Service Bulletin

Bulletin No.: 12-02-32-001A

Subject: Hydraulic Power Steering Leak at Hose Connection to Steering Rack

This bulletin is being revised to add the 2013 model year and change the tool part number in the Correction section. Please discard Corporate Bulletin Number 12-02-32-001 (Section 02 – Steering).

2760840

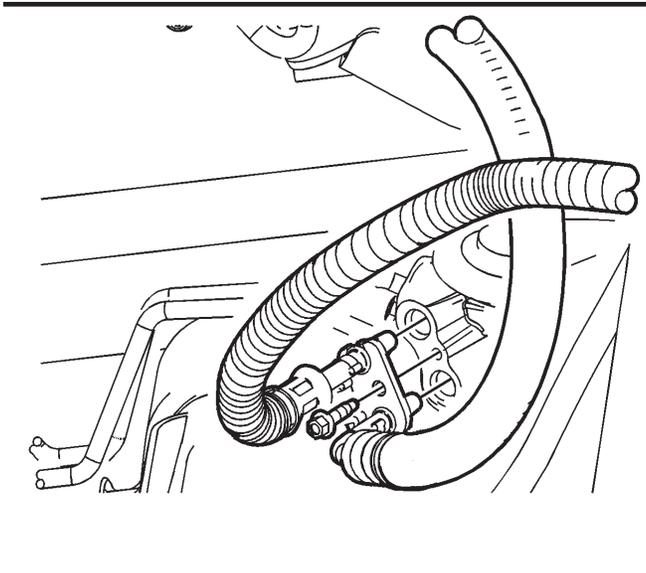
Some customers may comment on a fluid leak under the front of the vehicle. Upon further investigation, the technician may find fluid leaking from the power steering hose connection at the rack.

Based on parts returned to the Warranty Parts Center (WPC), replacement of both hose-to-rack “duckbill type” seals has corrected the condition. Replacement of the rack is not necessary for this issue.

2760840

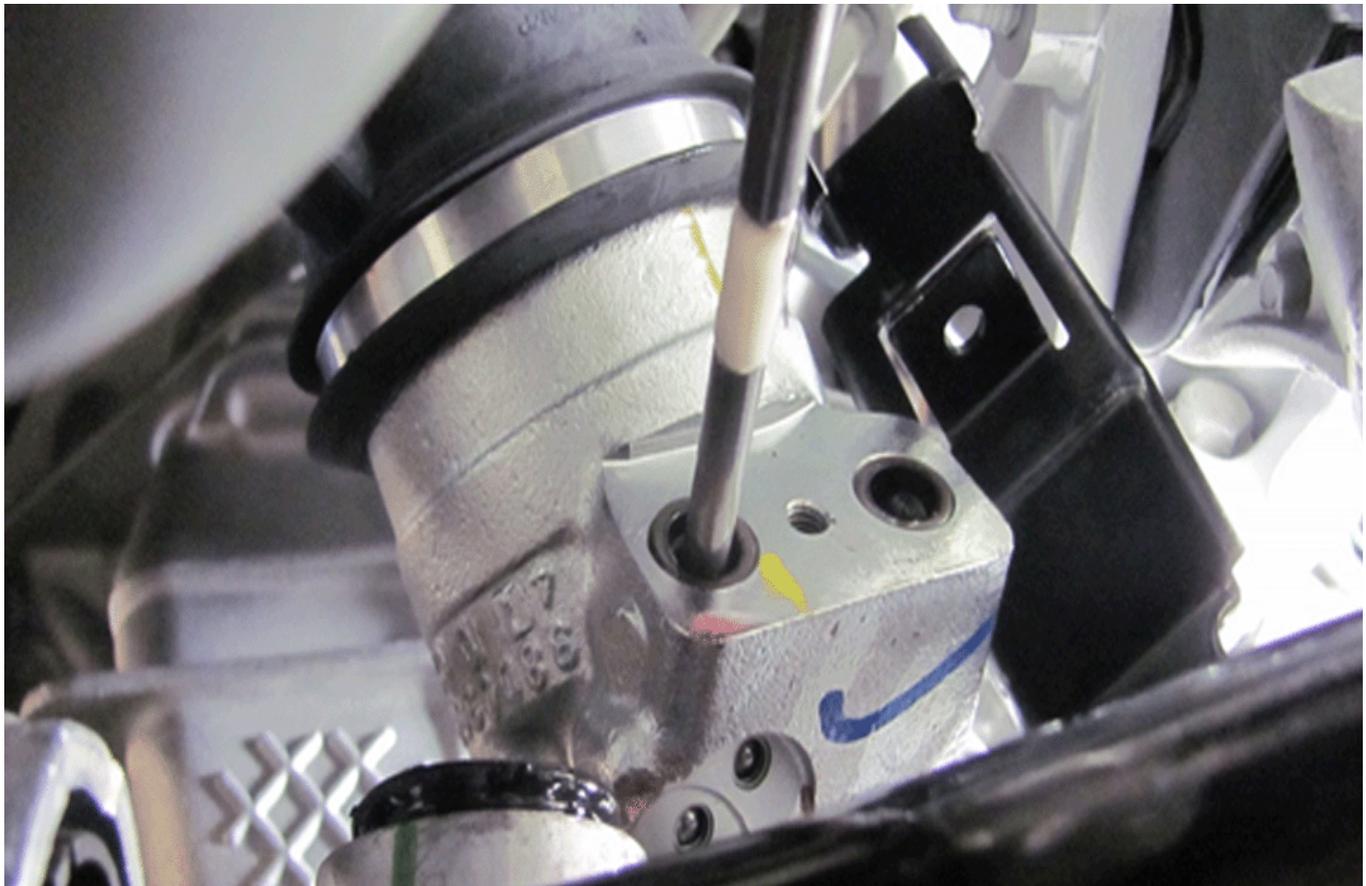
1. If not already done, remove the chip cover from the truck frame, exposing the hose/gear connection.
2. Remove the bolt fastening the connector plate to gear housing using an 8 mm hex socket and ratcheting socket wrench.
3. Grasp the hose tubes, one in each hand, and pull out from the connection, wiggling slightly as you pull back.

4. If the seals remain in the gear housing, remove them using the Kent Moore J-42640.
- Tip:** Do not utilize a screwdriver or any other sharp ended tool to remove the seals since such a tool could damage the housing bore.

5. Wipe the gear housing plate connection surface clean of oil and any debris. Place the replacement seal, P/N 26100863, in the counterbore and seat using the J-42640. Tap into place until the seal is firmly against the bottom of the counterbore. Do this for both ports.

Tighten the bolt to 12 N•m (106 lb in).
